#### Working Party on General Safety Provisions

#### Regulation No. 39 (Speedometer)

### **Proposal for draft 01 series of amendments to Regulation No. 39 (Speedometer)**

#### **Submitted by the expert from Belgium \***

#### Model A

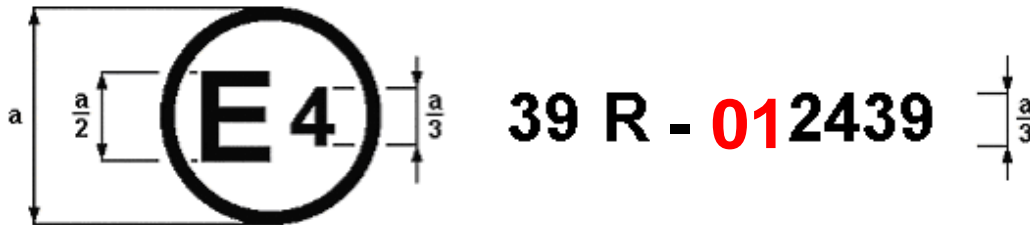
The above approval mark affixed to a vehicle shows that the vehicle type concerned has been approved in the Netherlands (E 4), pursuant to Regulation No. 39. The approval number indicates that the approval was granted in accordance with the requirements of Regulation No. 39 **incorporating the 01 series of amendments**.

#### Model B

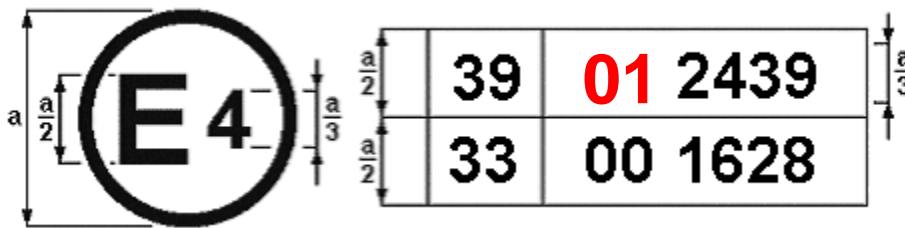
The above approval mark affixed to a vehicle shows that the vehicle type concerned has been approved in the Netherlands (E 4) pursuant to Regulations Nos. 39 and 33.<sup>1</sup> The approval numbers indicate that, at the dates when the respective approvals were granted, **Regulation No. 39 incorporated the 01 series of amendments and Regulation No. 33 was still in its original form.**
